Scott Horsley
Water Resources Consultant

November 13, 2023

RE: Thorndike Place

Figure 1 – Site Plan Hydrology (Groundwater Levels -Blue, Wetlands Elevations - Green)

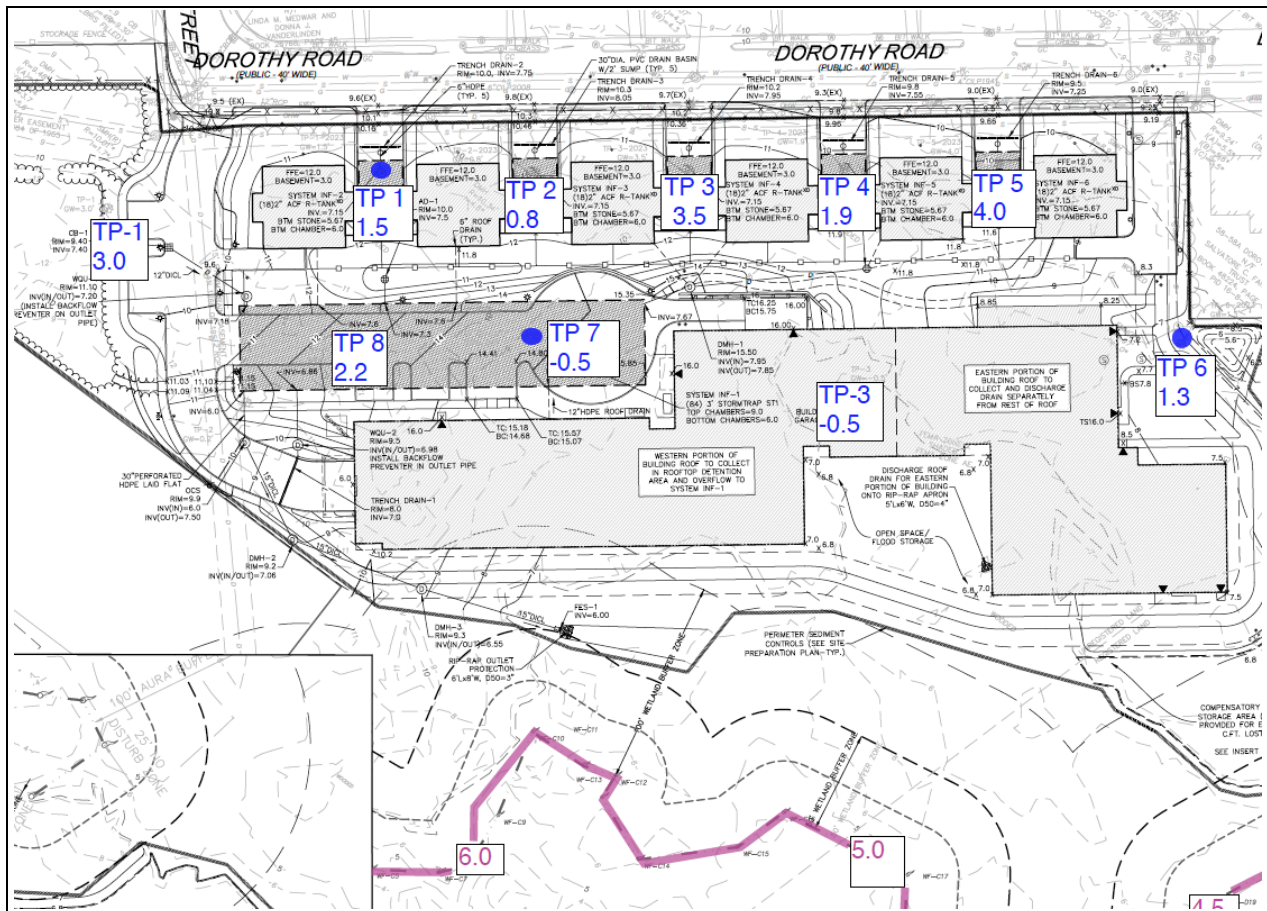
1. The reported groundwater levels are inconsistent with observed wetlands elevations and with each other. The site plan shows groundwater levels at ten test pits (see figure 1). These include two test pits conducted by BSC on November 25, 2020 and another eight by Whitestone on May 18 – 19, 2023¹. Some of the reported water levels appear to represent measurements made at the date of the test pits and in other cases are an estimated seasonal high groundwater level (ESHGW).

The reported groundwater elevations do not conform with an expected and typical hydrologic gradient that generally slopes from higher elevations in upland areas (near Dorothy Road) to lower elevations (in the wetlands). Wetlands generally function as groundwater discharge areas obtaining their flow from adjacent upland areas where recharge occurs.

The site plan shows elevations of 5 and 6 feet along the wetland boundary. Groundwater levels in wetlands are generally within 12 inches of the surface during the summer growing season and are estimated at 4 – 5 feet along the wetland boundary. This would suggest that groundwater levels in the upgradient upland areas should be higher (> 4 – 5 feet). Yet several of the reported groundwater levels in upland areas are significantly lower. Two of the measurements are reported at -0.5 feet (TP-3, and TP7). In summary, these groundwater elevations are inconsistent.

According to notes on the test pit soil logs monitoring wells were installed in several test pits (TP-1, TP-6, and TP-7)². However, groundwater level measurements at these wells have not been provided. Further analysis of groundwater levels is required.

Figure 3 – Hantush Model Results (Duration 0.46 Days - BSC, Stormwater Report, Revised September 2023)

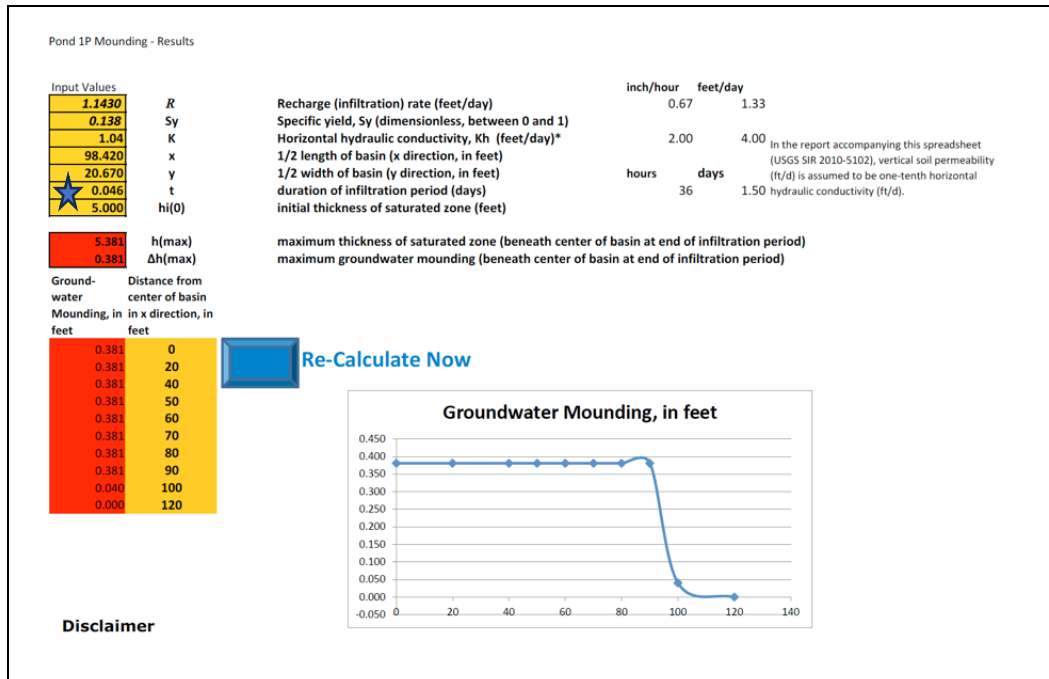
The Applicant has provided groundwater mounding calculations using the Hantush model in the Stormwater report⁵. Despite the large scale of the impervious surfaces and stormwater infiltration system, their model results indicate a small water level increase of 0.38 feet or 4.6

inches (see figure 3). However, the calculations provided in the Stormwater Report for the primary infiltration structure were limited to a duration (time of infiltration) of 0.046 days or 1.1 hours.

The design storms (10, 25, and 100-year) are required to be evaluated by the MADEP Stormwater Standards and are 24-hour duration events. The Applicant’s model limits the analysis to 1.1 hours and is clearly inadequate to represent the full impacts of the 24-hour storm event. It also does not take into account the significant increase in annual recharge volumes noted above.

The groundwater mounding analysis is inconsistent with the HydroCAD model that was also submitted by the Applicant. The HydroCAD model indicates that the 10-year storm will infiltrate 18,710 cubic feet through the bottom area of the infiltration facility (8137 square feet) at an infiltration rate of 0.52 inches/hour (1.04 feet/day)⁶. Dividing the infiltration volume by the surface area and the infiltration rate indicates that an infiltration time (duration) of 2.23 days (53.5 hours) is required to process the 10-year storm. This longer infiltration time will result in significantly higher groundwater mounding than reported in the Applicant’s Stormwater Report.

Figure 4 – Hantush Model Results (Duration 2.23 Days)

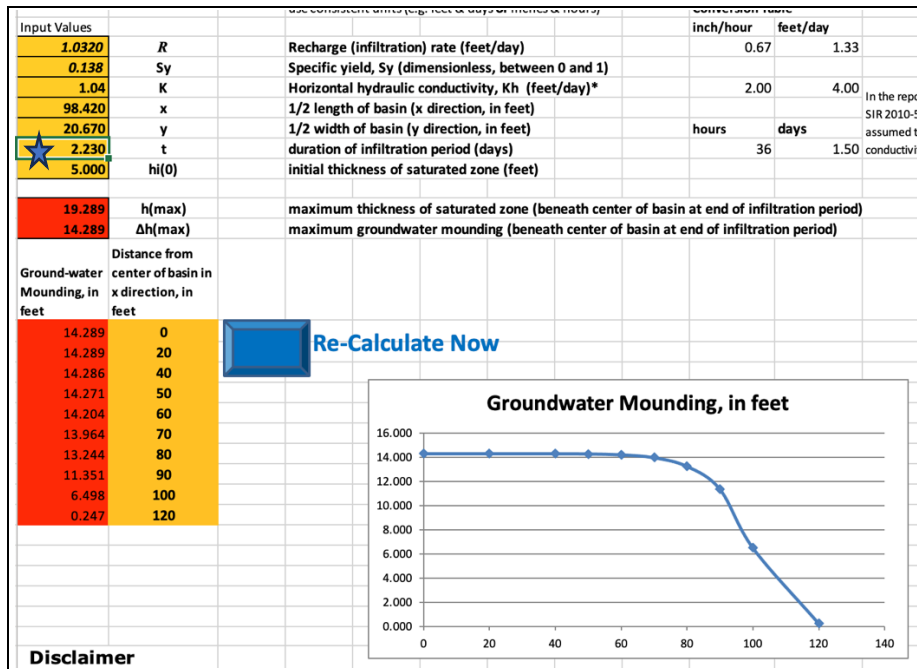
I applied the same Hantush model utilized by the Applicant with the corrected duration time of 2.23 days while maintaining the Applicant’s input values for hydraulic conductivity, saturated thickness, and infiltration system dimensions. The adjusted model shows a potential

groundwater mound of 14 feet at the location of the primary infiltration system and 6.5 feet at a distance of 100 feet (see figure 4).

This mounding elevation exceeds the 3-foot separation that the Applicant claims exists between the bottom of the leaching facility and the estimated seasonal high groundwater (ESHGW) and indicates that the groundwater mounding will inundate the infiltration system during the storm event. The inundation of the bottom of the infiltration facility will significantly reduce the infiltration rate and will lengthen the drawdown time. The MADEP Stormwater Handbook, Volume 1 (page 7) states, “Infiltration structures must be able to drain fully within 72 hours”. Further evaluation of drawdown times associated with the infiltration facility when it is inundated is required.

Figure 5 – Hantush Model Results – Long-Term (Steady State Conditions)

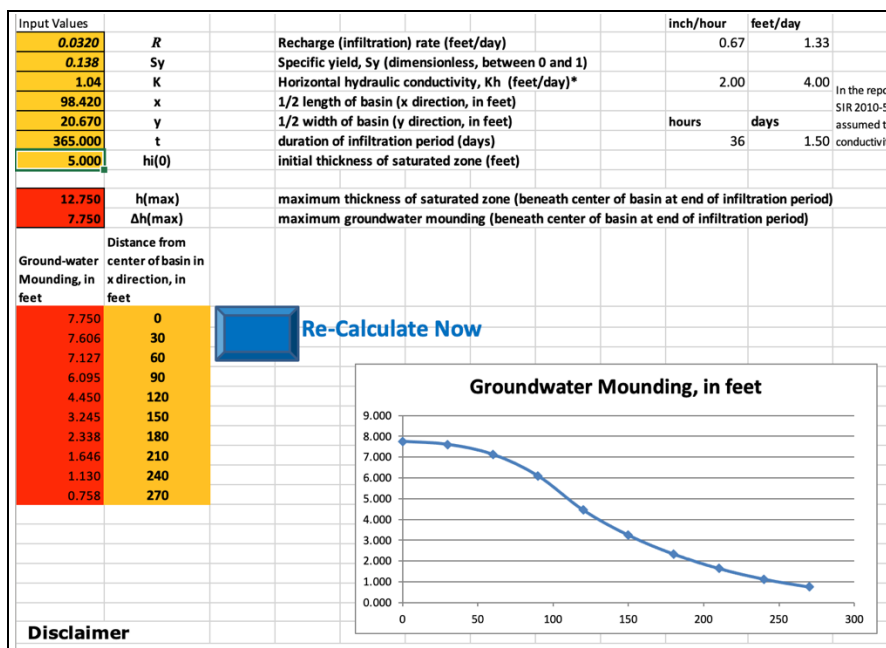
For the purpose of the long-term groundwater mounding analysis I applied the net change in recharge rate (17.5 to 38) of 20.5 inches/year. Applying the same values for hydraulic conductivity and saturated thickness provided by the Applicant I then simulated the long-term, steady-state groundwater mounding conditions (see figure 4). This analysis suggests that water table rises at the location of the infiltration system in excess of 7 feet (flooding the infiltration system) and approximately 2 feet at the wetland boundary. This is a significant alteration of the hydrologic regime of the bordering vegetated wetland. This level of mounding would also impact the basements of homes along Dorothy Avenue.

I recommend that the Conservation Commission require a more detailed groundwater mounding analysis using the USGS MODFLOW model that can evaluate both the post-development steady state groundwater conditions and transient conditions associated with the larger design storms. The USGS MODFLOW model can also incorporate boundary conditions and a calibrated water table. The more detailed analysis should include additional groundwater level measurements from monitoring wells and ESHGW adjustments utilizing USGS index wells.
